UNITED STATES PATENT AND TRADEMARK OFFICE

APPLICATION NO.	FILING DATE	FIRST NAMED INVENTOR	ATTORNEY DOCKET NO.	CONFIRMATION NO.
10/533,001	12/15/2005	Wybe Laverman	Stertil-1(P60856US00)	1678
7265 7590 12/27/2007 MICHAELSON & ASSOCIATES P.O. BOX 8489 RED BANK, NJ 07701			EXAMINER SCHILLER, ALINA	
			ART UNIT 3671	PAPER NUMBER
			MAIL DATE 12/27/2007	DELIVERY MODE PAPER

Office Action Summary	Application No. 10/533,001	Applicant(s) LAVERMAN ET AL.	
	Examiner Alina Schiller	Art Unit 3671

DETAILED ACTION

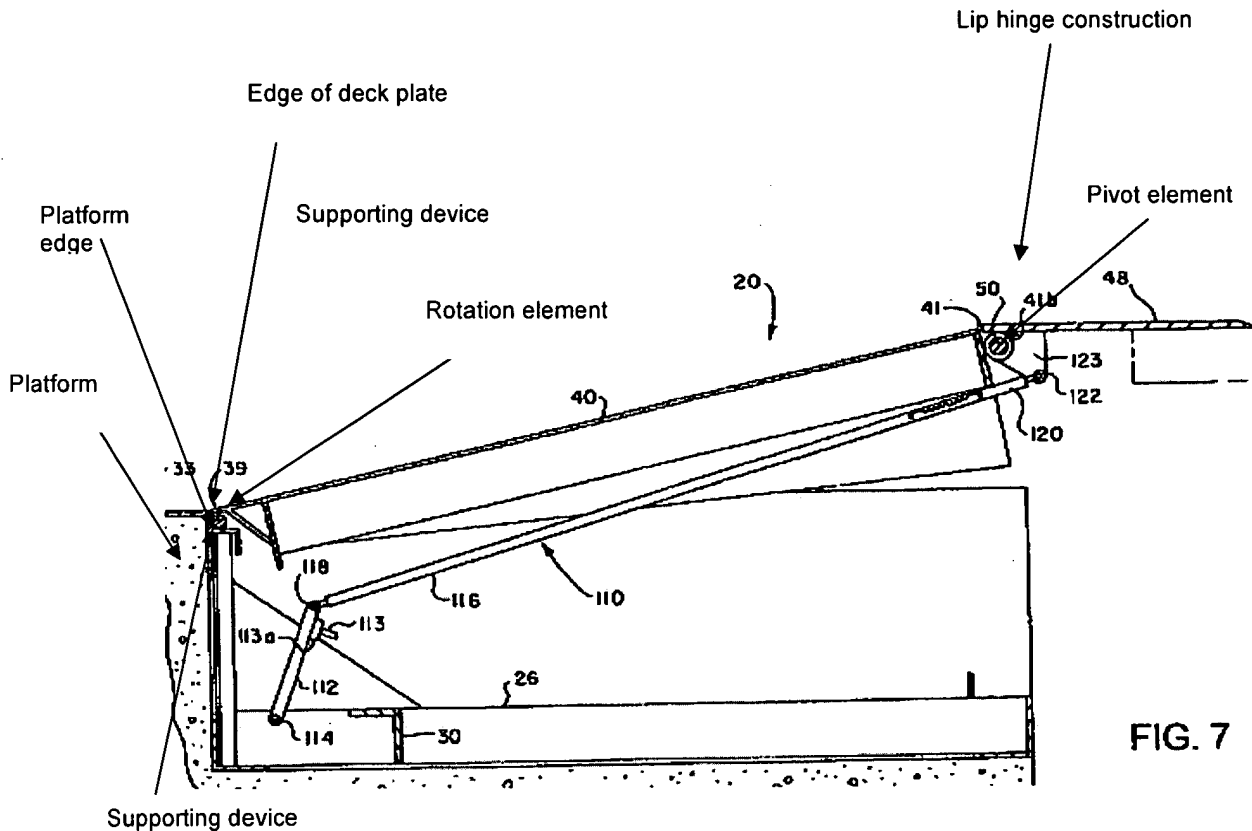
Regarding claim 1, DiSieno discloses a dock leveller (20, Figs. 5 and 7), comprising:

a deck plate (40) having a deck upper surface, which deck plate is pivotably connectible (as seen in Figs. 5 and 7) with a platform (as seen in the modified picture below);

a lip (48) having a lip upper surface, which lip upper surface, with the deck upper surface, forms at least a part of a transport surface (Abstract; as seen in Figs. 5 and 7);

a lip hinge construction (as seen in the modified picture below) with a pivot element which pivotably connects an end of the lip and an end of the deck plate of the dock leveler (as seen in the modified picture below), wherein the lip upper surface, through the pivot element, is pivotable below to a position in line with the deck upper surface, (as seen in Fig. 5), and further comprising:

a transmission member (110) for coupling a pivotal movement of the deck plate to a pivotal movement of the lip (as seen in Figs. 5 and 7).

However, DeSieno fails to disclose that the lip upper surface, through the pivot element, is pivotable above to a position in line with the deck upper surface. FR '436 teaches that it is well known to have a lip with the upper surface being pivotable both below and above to a position in line with the deck upper surface (Fig. 2). It would have been obvious to one having ordinary skill in the art at the time the invention was made to modify the dock leveler of DeSieno to have the lip rotatable upwardly and upwardly relative to the deck upper surface, as taught by FR '436, since this structure is well known in the art and provides a more versatile deck to lip relationship.

Regarding claim 14, DeSieno discloses an extension hinge construction (39), which is connected with an end of the deck plate remote from the lip, and is connectible with a platform edge (as seen in Fig. 7 and modified picture above).

a deck plate (as seen in Fig. 7), and
a supporting device (as seen in the modified picture above) for operatively supporting an edge of the deck plate on a platform edge (as seen in the modified picture above), at least one rotation element (as seen in the modified picture above) supported by the supporting device and situated near the platform edge, the edge of the deck plate being at least partly supported by the rotation element, and the deck plate being movable relative to the rotation element (as seen in the modified picture above).

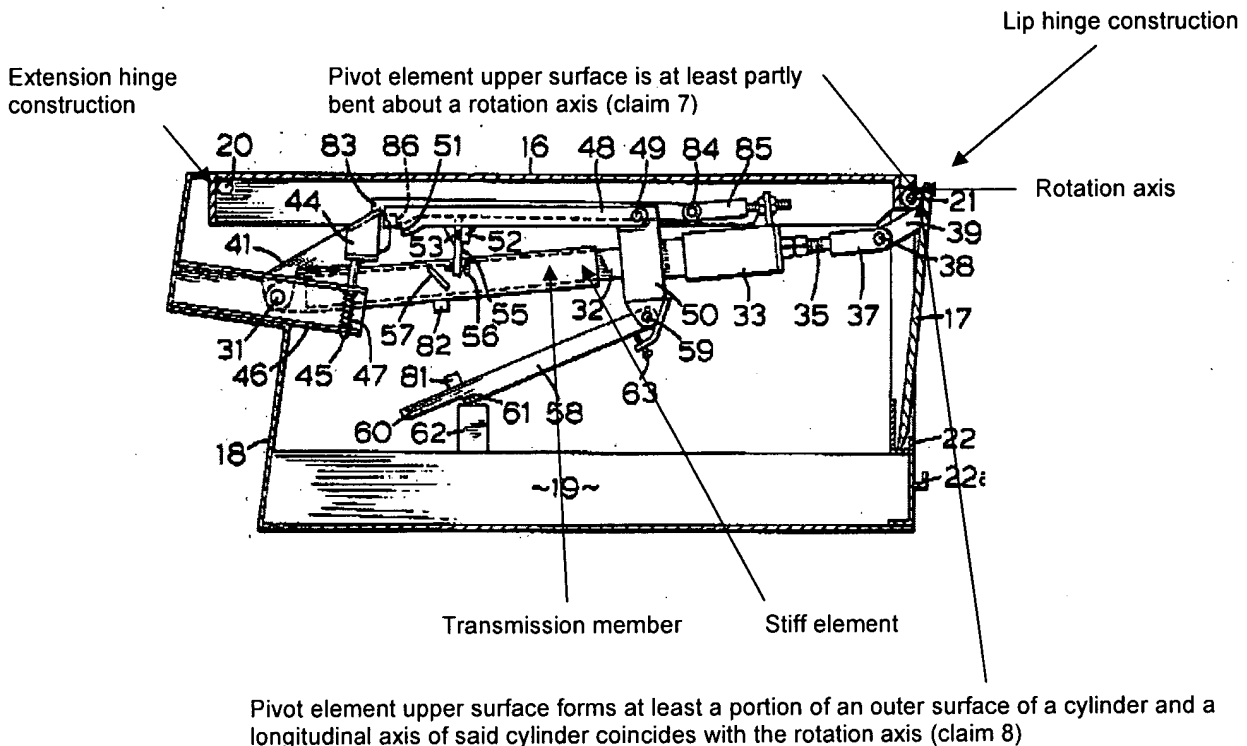
Regarding claim 1, Merrick discloses a dock leveller (as seen in Figs. 1, 2, 4 and 6), comprising:

a deck plate (16) having a deck upper surface, which deck plate is pivotably connectible (as seen in Figs. 4 and 6) with a platform (15);

a lip (17) having a lip upper surface, which lip upper surface, with the deck upper surface, forms at least a part of a transport surface (col. 3, lines 10-13; as seen in Fig. 2); and

a lip hinge construction (as seen in the modified picture below) with a pivot element (21) which pivotably connects an end of the lip and an end of the deck plate of the dock leveler (as seen in the modified picture below), wherein the lip upper surface, through the pivot element, is pivotable below to a position in line with the deck upper surface, (as seen in Figs. 7 and 8), and further comprising:

a transmission member (as seen in the modified picture below) for coupling a pivotal movement of the deck plate to a pivotal movement of the lip (as seen in the modified picture below).

However, Merrick fails to disclose that the lip upper surface, through the pivot element, is pivotable above to a position in line with the deck upper surface. FR '436 teaches that it is well known to have a lip with the upper surface being pivotable both below and above to a position in line with the deck upper surface (Fig. 2). It would have been obvious to one having ordinary skill in the art at the time the invention was made to modify the dock leveler of Merrick to have the lip rotatable both upwardly and downwardly relative to the deck upper surface, as taught by FR '436, since this structure is well known in the art and provides a more versatile deck-lip relationship.

Regarding claim 3, Merrick discloses that the transmission member comprises: a stiff element (as seen in the modified picture above) which is pivotably connected with the lip and is pivotably connectible with the platform (as seen in the modified picture above).

Regarding claim 14, Merrick discloses an extension hinge construction (as seen in the modified picture above), which is connected with an end of the deck plate remote from the lip, and is connectible with a platform edge (as seen in the modified picture above).
